WASTE TIRE PROCESSING FACILITY
PERMIT APPLICATION
ENTERPRISE CLASS III LANDFILL AND RECYCLING FACILITY
PASCO COUNTY, FLORIDA

Response To:
DECEMBER 16, 2010 FDEP REQUEST FOR ADDITIONAL INFORMATION

RESPONSE TO:
DECEMBER 16, 2010 FDEP REQUEST FOR ADDITIONAL INFORMATION

1 Waste Tire Processing Facility Site Plan

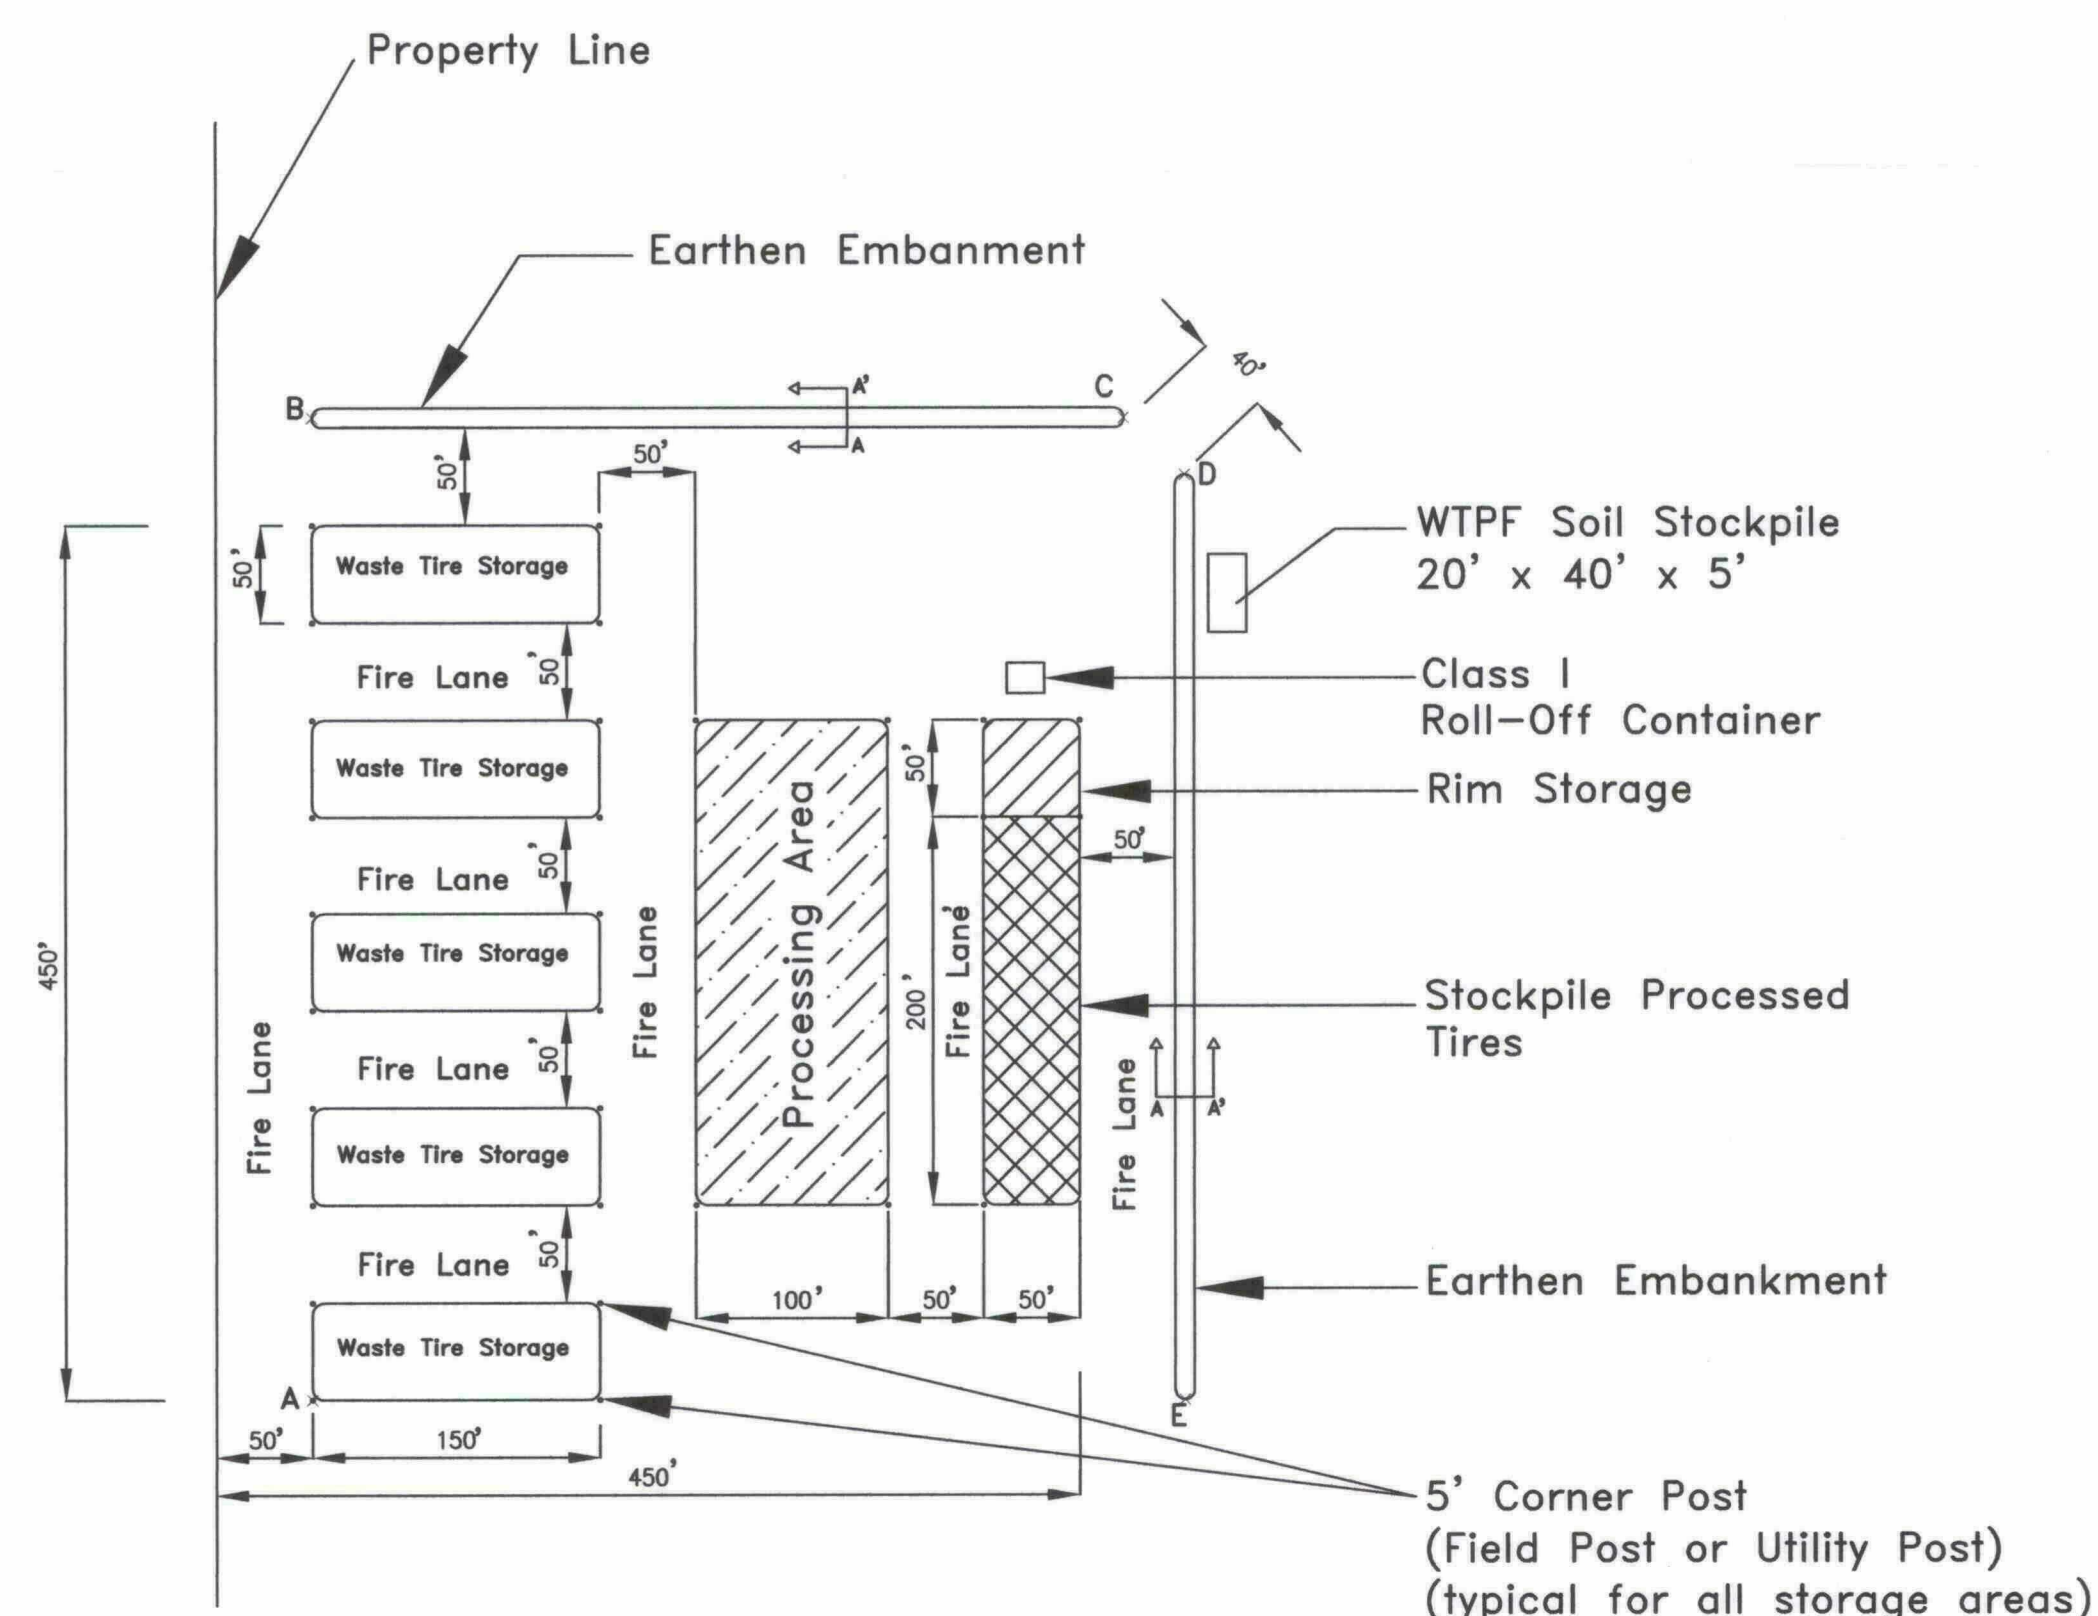
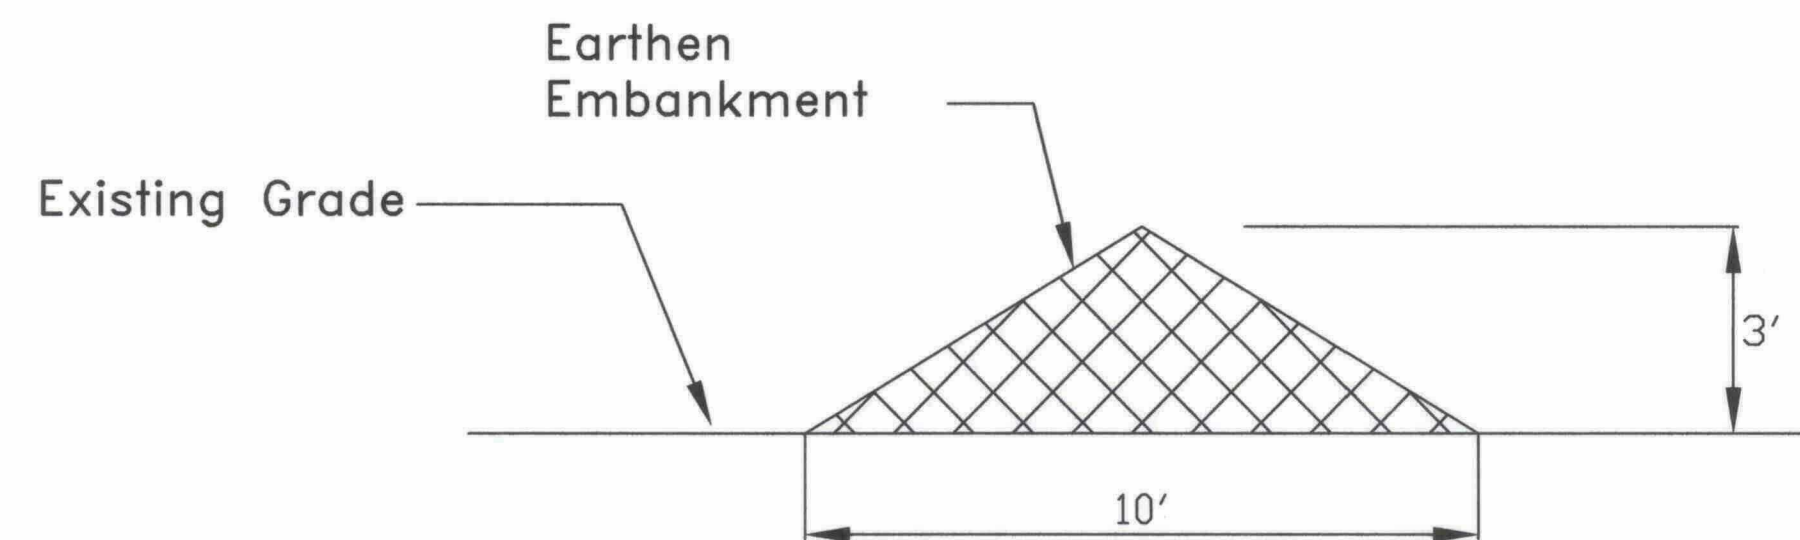
a. Section A. Facility Design. This section does not seem to include any specific information regarding construction of the facility. Please revise this section to include details regarding the construction of the facility, including, excavation, grading, paving, drainage, etc. See comment# 9. below.

d. Section B, Item 1. Please verify the number of storage pads to be used for storage of whole tires. This section references 6 pads for whole tire storage, while the proposed site plan shows 5 pads for unprocessed tire storage and one for processed tire storage.

9. Plans and Drawings, Rules 62-711.300(1) & 62-701.320(7)(f) F.A.C. Please provide detailed "construction-level" plans for the facility that use sheets 22 inches by 34 inches or 24 inches by 36 inches, prepared under the direction of and signed and

Response: The proposed WTPF is designed to be placed on existing grade without permanent site improvements, excavation, paving, or the installation of impervious area(s). The Site Plan drawing (C-1) has been revised to include lay-out coordinates and other details to delineate stockpiles, processing area, and other features. The information on the drawings is specific (e.g., coordinates, dimensions, and details) and sufficient to implement the proposed WTPF upon the existing grade. The revised drawing is provided in Attachment 2. The size of the WTPF has been reduced and we have revised the application accordingly. Page 2 of 4 of DEP Form No. 62-701.900(23) has been revised to include the new storage capacities and is included in Attachment 1.

Response: There are five (5) whole tire storage areas. Part III – Attachments, Section B, Item 1, has been revised accordingly (Attachment 4).

Response: The Site Plan has been revised to remove the reference to "inert debris." The Site Plan is printed on a 24" x 36" sheet (Drawing C-1) and includes the "ENTERPRISE CLASS III FACILITY – SITE PLAN" and "WASTE TIRE PROCESSING FACILITY – SITE PLAN" details that are at scales of 1"=200' and 1"=100', respectively. Drawing C-1 was prepared under the direction and has been signed and sealed by Florida registered professional engineer. The WTPF Site Plan provides the coordinates and dimensions necessary to layout and construct the proposed WTPF, including whole tire stockpiles, fire lanes, processed tire stockpile, corner posts, Class I roll-off box, rim stockpile, earthen embankment, and soil stockpile.
